**Display**

Subject: **NO OUTPUT OF BUILT-IN SIGNALS**

Model: **BVM-14E1U, BVM-14E5U, BVM-14F1U  
BVM-14F5U, BVM-14G1A, BVM-14G1E  
BVM-14G1U, BVM-14G5A, BVM-14G5E  
BVM-14G5U, BVM-20E1U, BVM-20F1U  
BVM-20G1A, BVM-20G1E, BVM-20G1U**

**Figure 1**

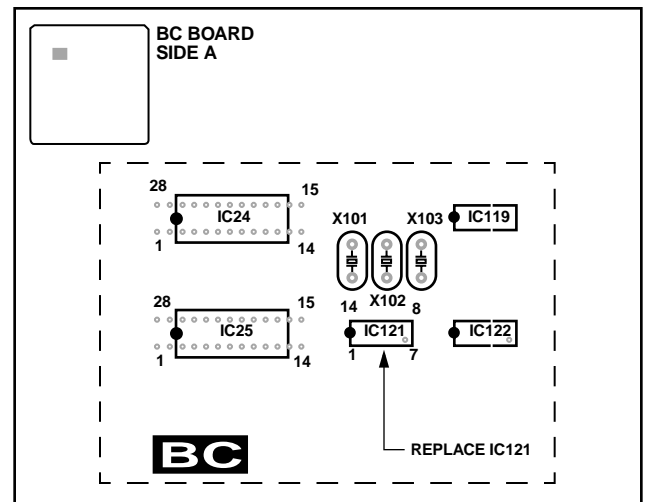
**BC Board, Side A  
(See Figure 1.)**

1. Replace IC121 (TC74VHCU04) with the new IC MC74HCU04AF.

2. Select 525/60 CH100 PLUGE signal in MAINTENANCE/BC BOARD /TEST SIGNAL.
3. Confirm that 525/60 PLUGE signal appears.
4. Advance to page 3/3, and select 625/50 CH115 PLUGE signal.
5. Confirm that 625/50 PLUGE signal appears.
6. Implement following steps on BVM-E and F series only:
  - a. Feed a signal containing VITC and confirm that the VITC can be displayed.
  - b. If a signal containing VITC is not available, extend the BC board with the extension board and confirm the following.
  - c. Connect an oscilloscope or a frequency counter to pin 8 of IC121 on the BC board, and confirm that a clock of 14.5 MHz is output.
